Property Location: 506 S. Lahoma Avenue
Chautauqua Historic District

COA Request: **(HD Case 15-13)** Consideration of a request for a Certificate of Appropriateness for the installation of a garage, additional concrete paving, an 8 foot rear yard fence, 6 foot side yard fence and a covered patio for property located at 506 S. Lahoma Avenue.

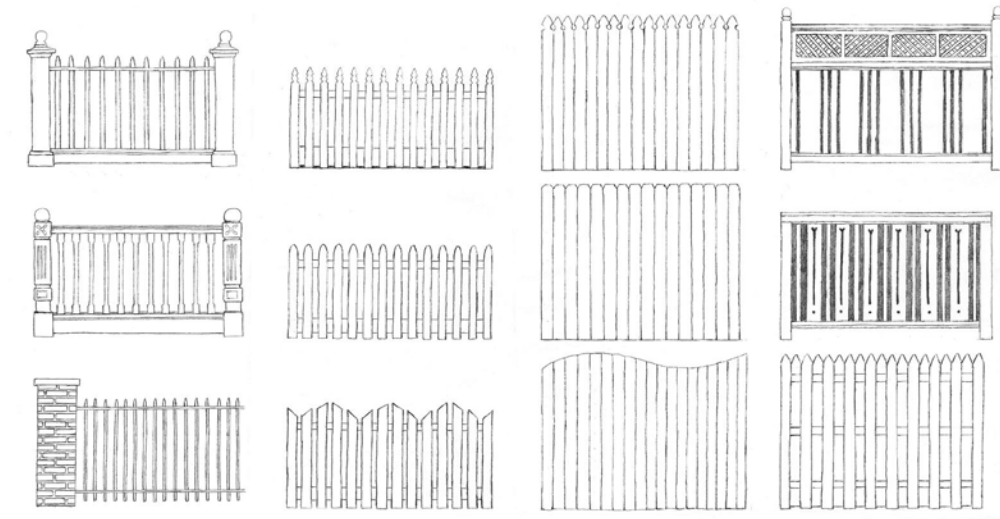
If the garage is approved, additional pavement would be required in order to provide access to the garage doors. Currently, the pavement on the site is approximately 2,632 square feet. The proposed additional paving (paving that is not covered by a structure) would add 1,018 square feet of paving, all of which would be located in the rear yard. Not all of the additional paving requested appears to be necessary to access the garage. If the garage and patio are approved, the amount of paving approved should be limited to what is necessary to access the garage. Currently the existing parking pad allows for the parking of three cars, which is more than typical of what is found in the district. If the garage is not approved, the paving requested for the rear yard would not be compatible with the character of this backyard or the district and would overwhelm the backyard.

Staff Recommendation: Staff recommends denial of the additional parking if the garage is not approved. Staff recommends if the garage is approved that only the parking needed to provide access to the garage be approved.

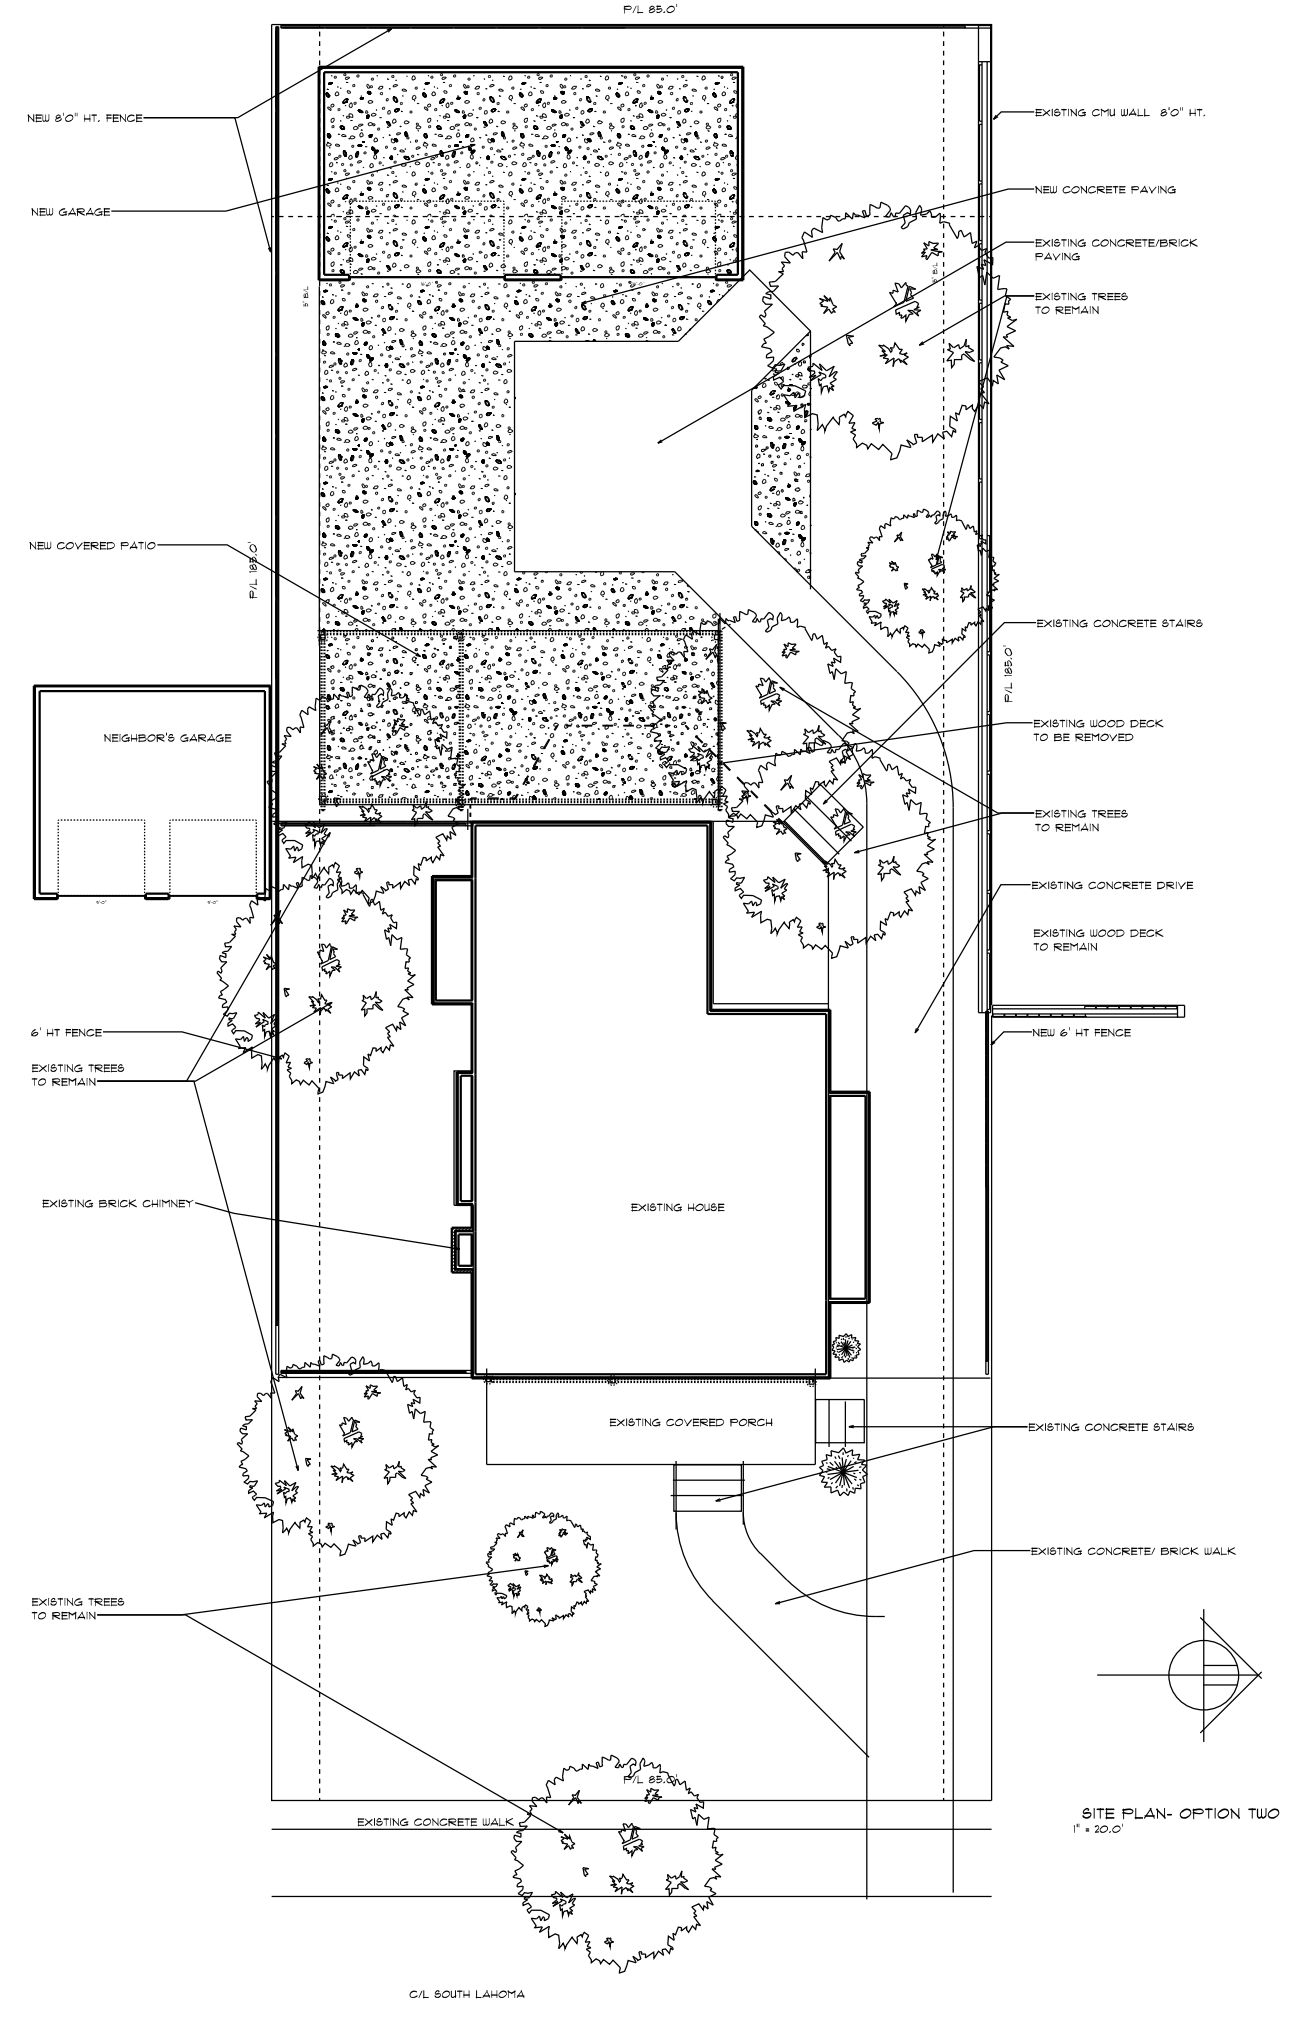
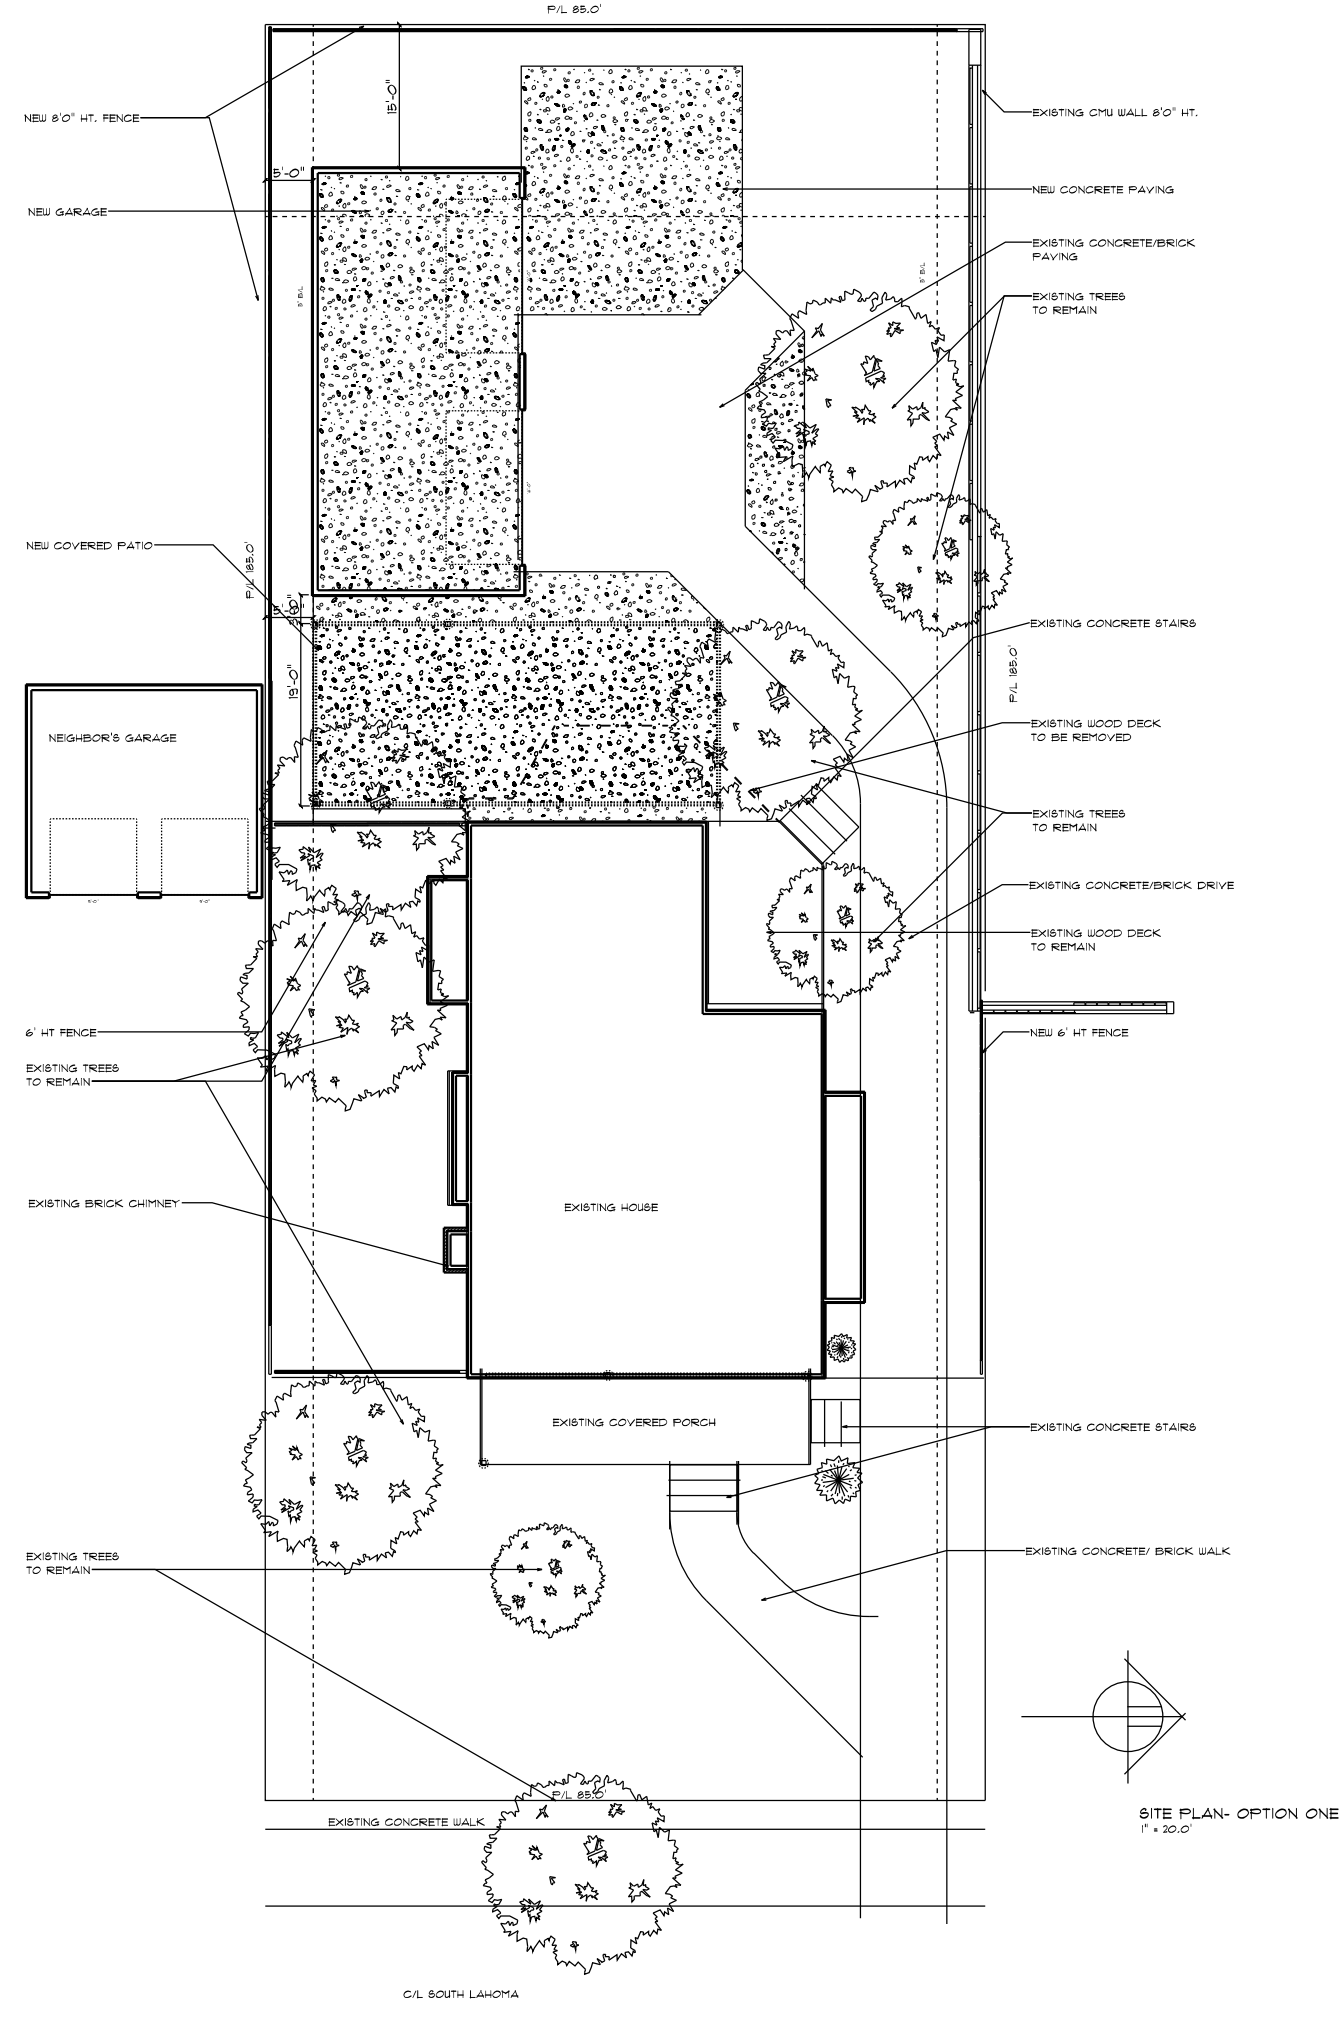
The proposed wood patio cover structure will be located on the rear elevation as required by the Guidelines. However, the patio will extend approximately 15 feet beyond the southwest rear corner of the house and will be visible from the street. This does not meet the Guidelines for locating the patio inconspicuously. An elimination of the 15 feet of width that extends beyond the side of the house would allow the patio to meet the guideline.

The proposed wood patio cover structure will be a simple design that will be of similar materials as the primary structure and is compatible to the principle structure. While a 760 square foot patio is a large patio, the addition of a cover significantly increases the mass making it out of proportion for this yard. The scale and proportions of the wood patio cover structure as mentioned above would need to be scaled down to bring it into compatible size with this house and the district.

If the wood patio cover structure was reduced in size by eliminating 15 feet of width as suggested above, it would then be compatible in size and would not detract from the overall character of the building, site or district. In addition, as mentioned earlier in the staff report, concrete paving should not abut the principle structure and it is recommended that a more pervious hardscape surface should be used such as pavers or flagstone. Since the purpose of this wood patio cover structure is for an outdoor living space a barrier that would delineate the patio area should be installed. This would prevent the patio from becoming another parking area and give this space a more appropriate residential outdoor living space feel. These alterations would help prevent the proposed wood patio cover structure from detracting from the character of the site.

Staff Recommendation: Since the wood patio cover structure does not meet the Section ***4.1 Guidelines for Decks*** in regards to the scale, and size, staff recommends denial of the wood patio cover structure as submitted.
